Chatham County Planning Board Agenda Notes

Date: January 5, 2021

Subject: A request by Mark Ashness, P.E., on behalf of Laurel Ridge Development, Inc. for subdivision Final Plat review and approval of **Laurel Ridge Phase 1B**, consisting of 12 lots on 68 acres, located off Old NC 87, SR-1520, Hadley Township, parcel #82018.

The following map shows the location where this phase of the Laurel Ridge is located.

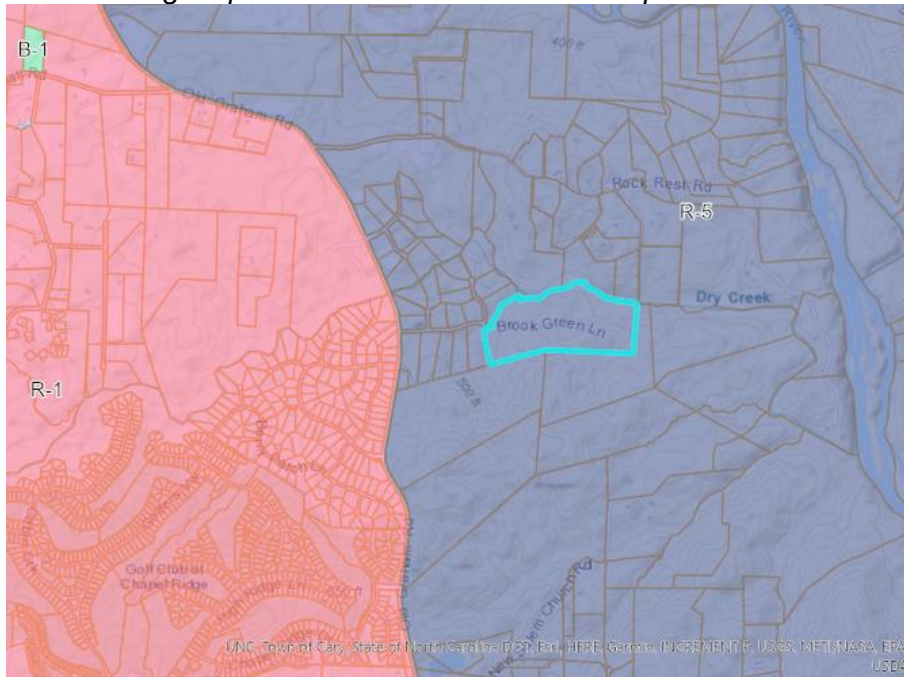
Riparian buffer widths of 50 feet per side (100' total) measured from top of bank landward have been shown on the plat, as well as the 100-year and 500-year floodplain. The Technical Review Committee met November 10, 2020 to review the request. Hadley Swain Kirkland, developer, was present. Staff discussion included, if previous issues with Watershed Protection Dept. were complete, location of a cemetery, and water line size to the fire hydrants. Rachael Thorn, Watershed Protection Director stated the issues were resolved. The cemetery is located on parcel 86403 not in the proposed area. Chief Strowd had concerns that a 4-inch water line to the fire hydrants would not suffice, Mr. Ashness stated the lines to the fire hydrants wasn't 4 inches.

Several residents spoke of their concerns during public input of the Planning Board meeting. Elaine Chiosso had concerns with pollution and sediment issues in Dry Creek, violation of sediment and erosion control requirements, and doesn't want pollution in the creek. She believes the pre-'08 regulations are old rules when it comes to stormwater treatment and

buffers. She would like the lots reconfigured to be larger with less lots and would like a 100' wide buffer on Dry Creek.

Cari Filer also requested a 100' wide buffer on Dry Creek and expressed concerns with private drainage on Lots 13 and 14. She also questioned what steps were taken to mitigate the stormwater runoff and slow it down as it proceeds to the protected wetland areas and if there was any tree protection.

Board members discussed the 50' wide buffers on Dry Creek and two tributaries running into Dry Creek, whether there was any history of drainage problems with the culvert over the road, and asked the developer to consider increasing the 50' wide buffer to 100' wide buffer along Dry Creek. Mr. Ashness confirmed there are two tributaries that flow into Dry Creek and there are 50' wide buffers shown on both sides of the water features. He commented that the drainage area to the culvert is a well-defined channel and the drainage area isn't very substantial and hasn't had any problems. NCDOT has reviewed the public drainage area and it will be turned over to NCDOT for maintenance in the future. The board asked if the developer would be willing to increase the buffer from 50' wide to 100' wide along Dry Creek, Mr. Ashness stated he would need to talk with his client. The board decided to postpone a vote to January 5, 2021 meeting to give Mr. Ashness time to communicate with the developer.

Mr. Mark Ashness, P.E. spoke on behalf of the developer. Mr. Ashness explained that the lots were 5 acres average with shoulder and ditch sections, no curb and gutter, no extensive piping on the property, and no plans for mass grading. Due to the size of the lots, there are no issues with concentrated runoff or any high velocity issues.

Since the December 1, 2020 Planning Board meeting, the developer has agreed to place an additional 50' voluntary buffer and a copy of the revised survey can be found on the following website - <https://www.chathamnc.org/government/departments-programs/planning/rezonings-subdivision-cases/2020-items/laurel-ridge-phase-1b-final-plat-4804> .
